AK C PPCs 48, 49 & 50 – JWS Stormwater (Planning) – 14 October 2021.

PRIVATE PLAN CHANGE 48: DRURY CENTRE PRECINCT – KIWI PROPERTY HOLDINGS

JOINT WITNESS STATEMENT (JWS) OF EXPERTS IN RELATION TO STORMWATER (PLANNING)

IX. Drury Centre Precinct (14 October 2021)

IX.10.1 Drury Centre: Precinct plan 1 – Building Height

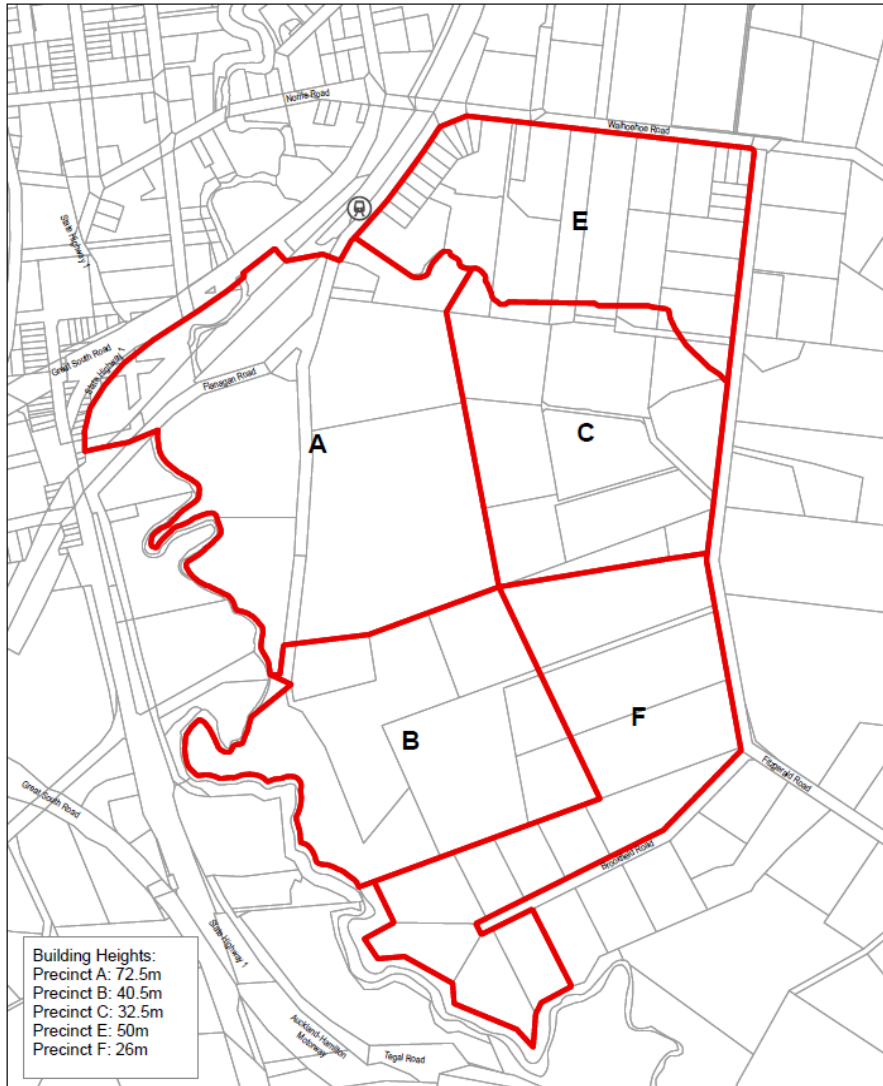
Commented [BA113]: Precinct Plan 1 amended to:
 -Remove sub-precinct D and integrate with A (AT 27.44 & KiwiRail 24.5)
 -Realign sub-precinct A, C & E boundaries with Maketu Stream
 -Increase heights in Sub-precincts E, C & F (Kiwi Property 15.6)
 Show revised indicative location of the Drury Central train station (NZTA 23.3, KiwiRail 24.12, Amendments also made in response to s42A recommendations.)

IX.10.2 Drury Centre: Precinct plan 2 – Road Network and Spatial Features

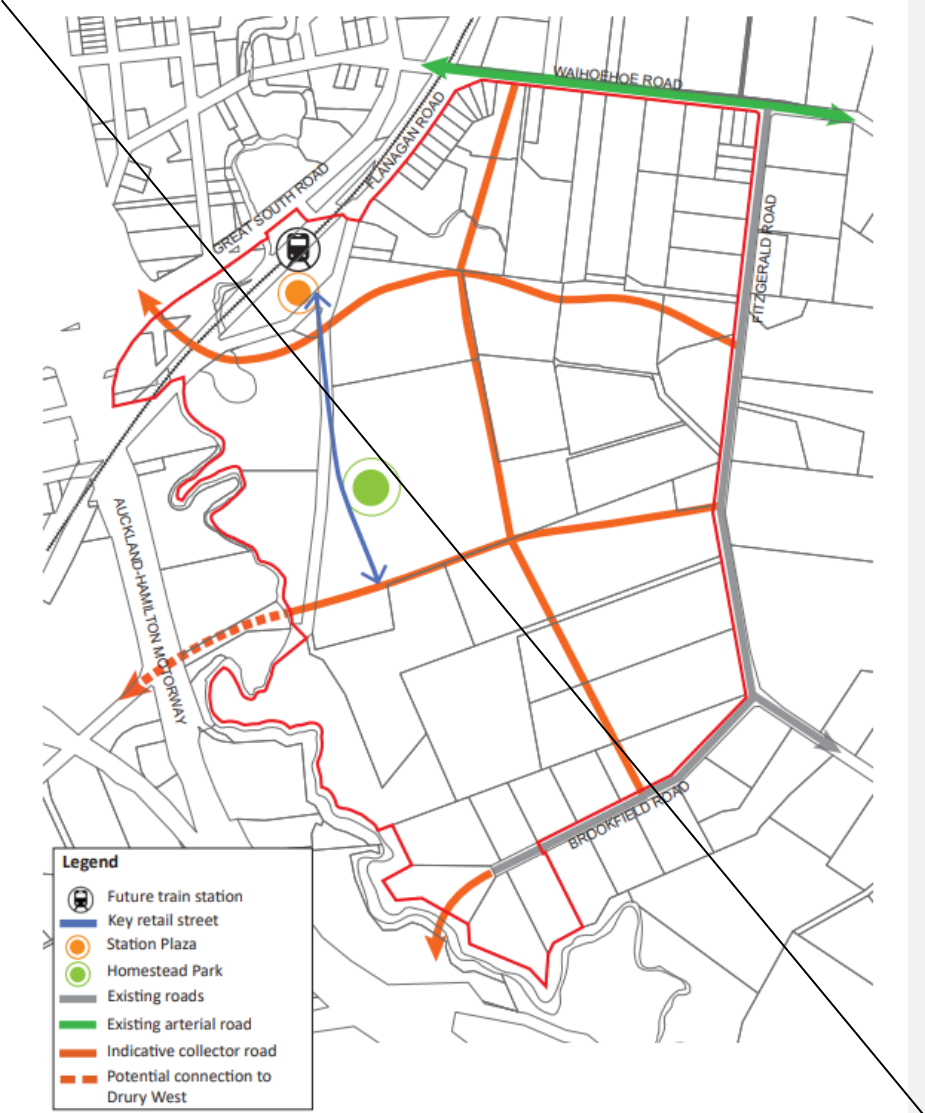
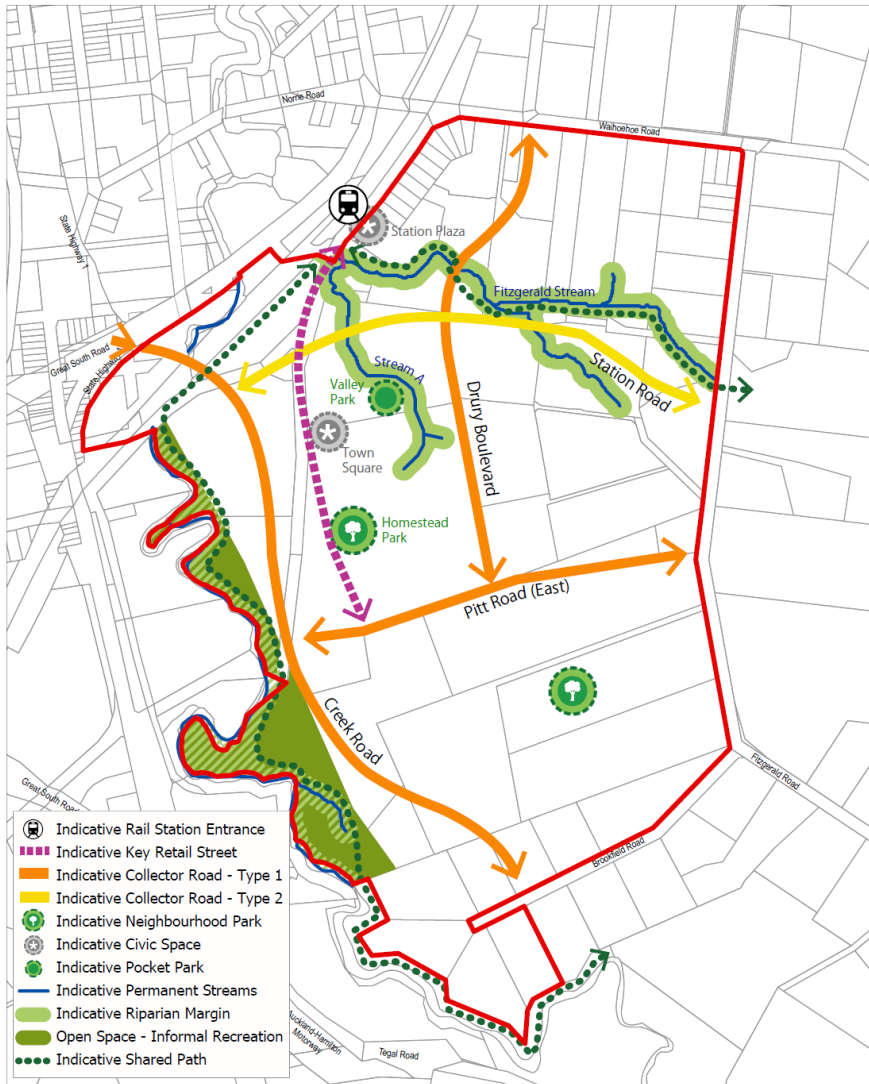
Commented [BA114]: AT.27.43 & NZTA 23.6

Precinct Plan 2 amended to:

- Revise the location of the collector roads to align with the Drury Centre Masterplan
- Show revised indicative location of the Drury Central train station
- Revise the location of the Key Retail Street to integrate with the Drury Central train station
- Show the indicative open space network, including shared paths
- Show a different collector road status for Station Road.

IX.10.2(2) Drury Centre: Precinct plan 2A – Road Network and Key Retail and General Commercial Frontage controls

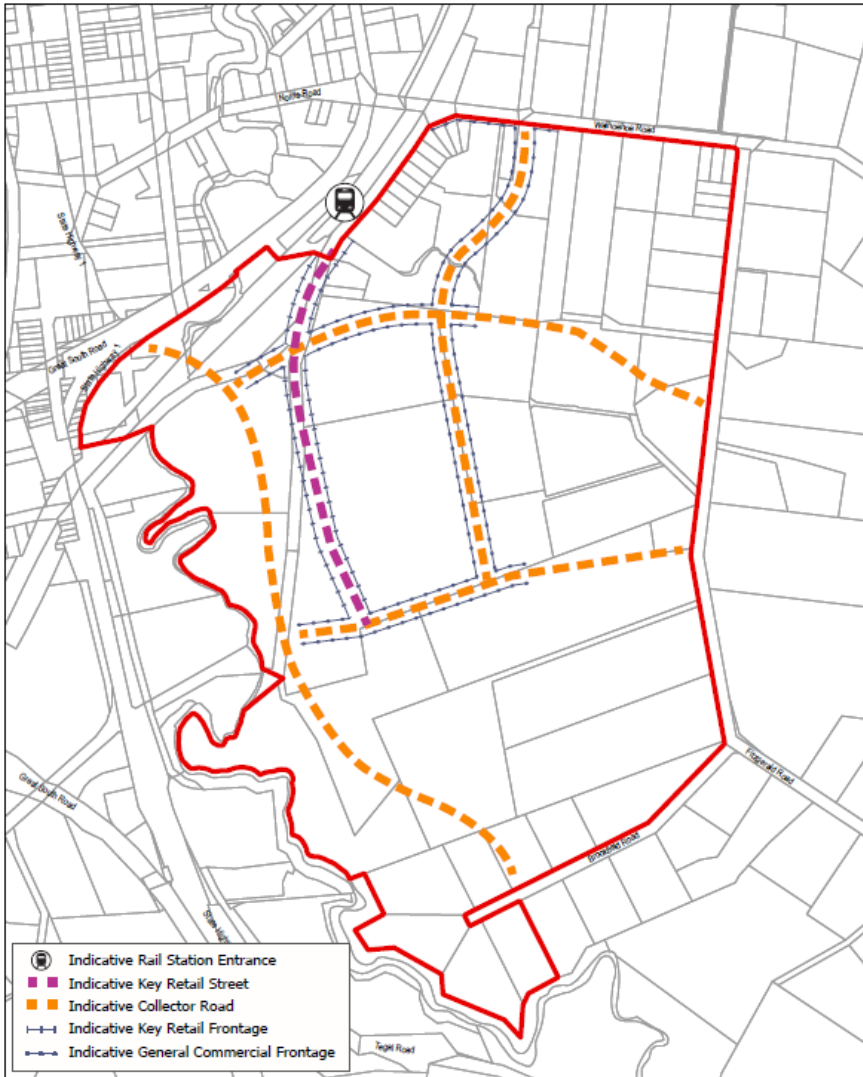
Further amendments made in response to the evidence of Christopher Turbott for Auckland Council:
 - "indicative" added to Key Retail and General Commercial Frontage

Additional wording to state that the frontage controls apply to sites adjoining the final location of the Collector Roads.

Note: The Key Retail and General Commercial frontage controls apply to sites adjoining the final location of Collector Roads and the Key Retail Street as determined through a resource consent process.

IX.10.3 Drury Centre: Precinct plan 3 – Transport Staging Boundary

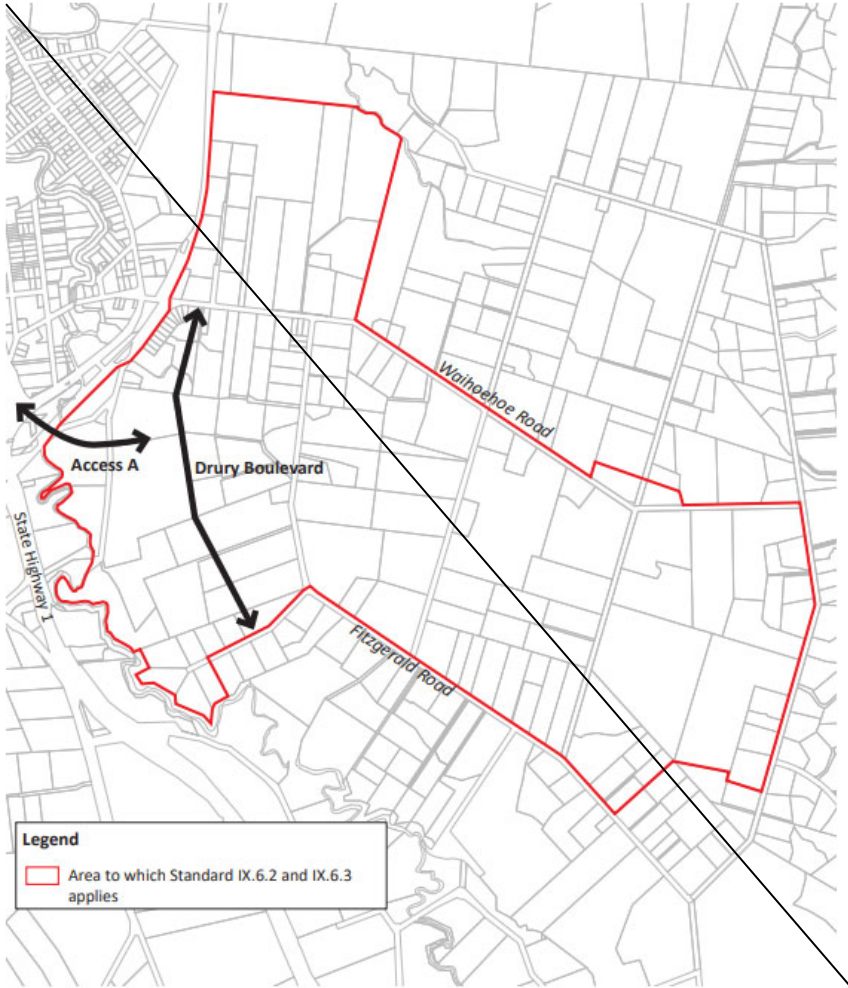
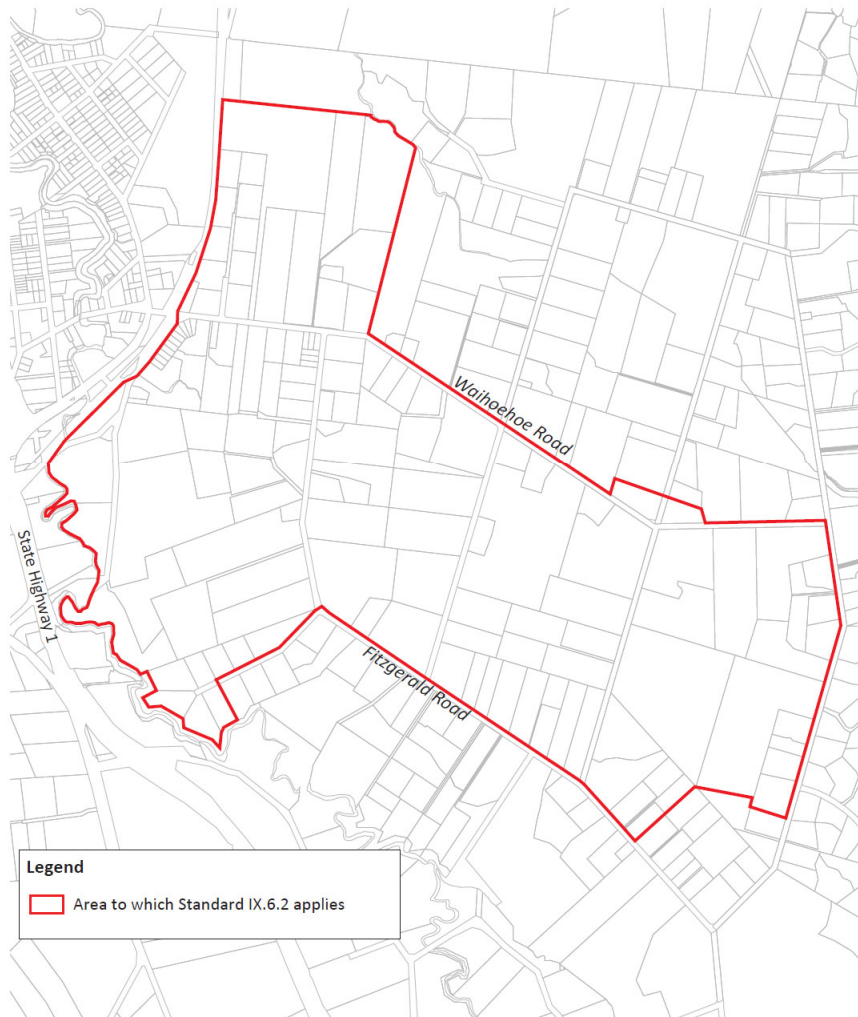
Commented [B&A116]: Consequential amendments to update Precinct Plan 3 to align with new transport trigger provisions.
